Verdin Development Board

Errata Document

Figure 1 Verdin Development Board CTRL_FORCE_OFF_MOC1# pull-up patch (Top Side)

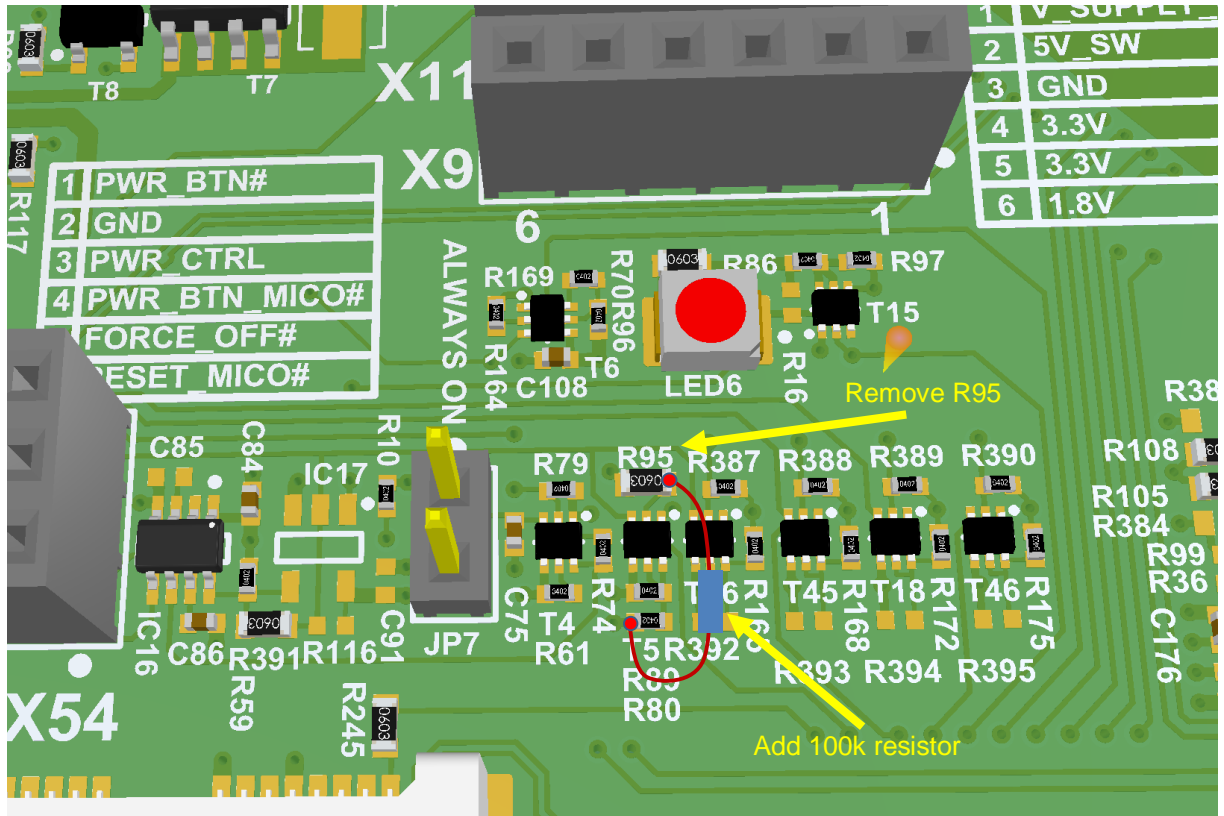
Errata #4: HAR-3935 – CTRL_FORCE_OFF_MOCI# is pulled-up to wrong voltage rail

The main power gets killed as soon as the CTRL_PWR_EN_MOCI# goes low and the +V1.8_SW rail is turned off. This means the main power is killed during a reset cycle, and the power-down sequence is not graceful.

According to the Verdin specifications, the CTRL_FORCE_OFF_MOCI# is an open-drain output of the module, which is 5V tolerant and requires a pull-up resistor on the carrier board. On the Verdin Development Board V1.0B, the CTRL_FORCE_OFF_MOCI# is pulled up to the +V1.8_SW rail. Unfortunately, this rail is switched by the CTRL_PWR_EN_MOCI# signal. During a reset cycle (software or button initiated), the CTRL_PWR_EN_MOCI# signal can go low for power cycling the peripherals on the carrier board. This is also disabling the +V1.8_SW, which means the CTRL_FORCE_OFF_MOCI# goes low and triggers the kill input of IC16. The IC16 will then kill the main power of the module. This means resetting the module can cause an unintentional power-off of the system.

During a regular power-down cycle, the CTRL_FORCE_OFF_MOCI# signal is supposed to go low as the last step after all the module and carrier board peripheral rails are shut down in the correct order. Due to the incorrectly pulled up CTRL_FORCE_OFF_MOCI# signal, the main power gets killed in a too early state. This means the power rails are not shut down in the intended graceful sequence. Even with this non-graceful shutdown, damages on the module or carrier board are not expected.

Removing R80 disables the CTRL_FORCE_OFF_MOCI# signal on the Verdin Development Board. However, this disables the “kill-feature” entirely. Therefore, after a shutdown, the supplies are not turned off, which prevents the system from being turned on by using the power button. For turning on the system, either power cycle the whole board or turn off the main 3.3V rail on the carrier board by pressing the power button for >3s. Besides this inconvenience, the modification is compatible with all Verdin module versions.

An alternate workaround is removing R95 and adding a 100kΩ pull-up resistor from CTRL_FORCE_OFF_MOCI# to +V5_STB. This makes the circuit fully compatible with the new Verdin modules. The kill-feature would work with this modification as intended with the new Verdin modules. However, for the older Verdin iMX8M Mini V1.0B module, the CTRL_FORCE_OFF_MOCI# is not 5V tolerant and the CTRL_FORCE_OFF_MOCI# signal gets also asserted during the reset cycle. This means after the modification, the development board is not compatible anymore with the Verdin iMX8M Mini V1.0B. Read Errata #13 and Errata #5 of the Verdin iMX8M Mini V1.0B module for more information. The following picture shows one potential implementation of the alternate workaround patch:

Figure 2 Verdin Development Board – location of R188 (Top Side)

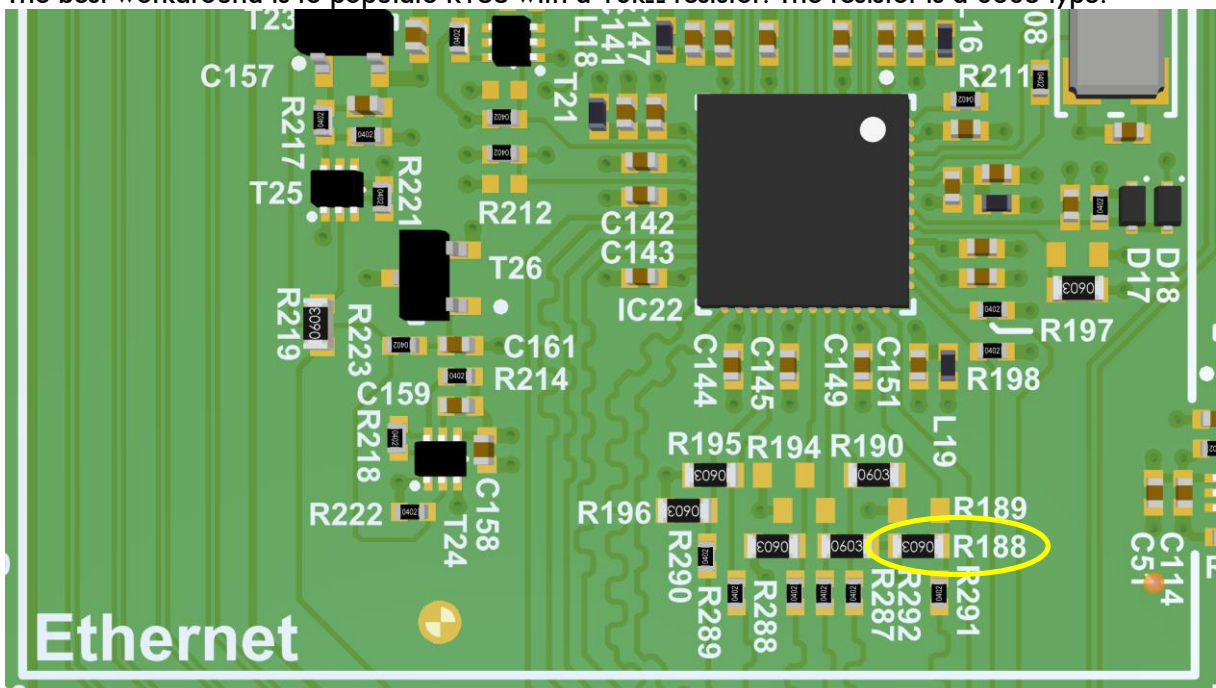
Errata #5: HAR-6600 – Ethernet PHY address strapping resistor for configuring PHYAD2 missing

In combination with the Verdin iMX8M Plus, the Ethernet PHY on the carrier board (which is connected to the RGMII interface of the SoM) gets strapped to address 0b00011 rather than the intended 0b00111. This address is not compatible with the default address configuration used in applicable Toradex software, causing the 2nd Ethernet interface of the carrier board to be non-functional. The strapped value and the resulting PHY address - in combination with future Verdin modules - may be different.

The last three bits of the PHY address are strapped by the PHYAD0, PHYAD1, and PHYAD2 pin. PHYAD0 and PHYAD1 are located on the LED output signals, which are strapped correctly. PHYAD2 is located on the RXC pin of the PHY (ETH_2_RGMII_RXC signal). The strapping resistors R188 and R189 are both missing in the BOM. Intended by design is to strap the signal high by assembling R188. Since both strapping resistors are missing, the strapping value is dictated by the module’s behavior of the ETH_2_RGMII_RXC signal during the enabling of the Ethernet power rails. The Ethernet power rails are enabled on the carrier board by the PWR_CTRL_4 signal.

The Verdin iMX8M Plus has a weak pull-down enabled on the ETH_2_RGMII_RXC by default. Therefore, the PHY address gets strapped to 0b00011 rather than the intended 0b00111. In this case, the module can only communicate over the MDIO interface with the PHY if the driver changes the address to 0b00011.

The best workaround is to populate R188 with a 10kΩ resistor. The resistor is a 0603 type.

An alternate workaround is changing the PHY address to 0b00011 in software. However, this causes the software to not be compatible with newer versions of the Verdin Development Board and the other Verdin carrier boards following the same PHY address recommendation/convention.
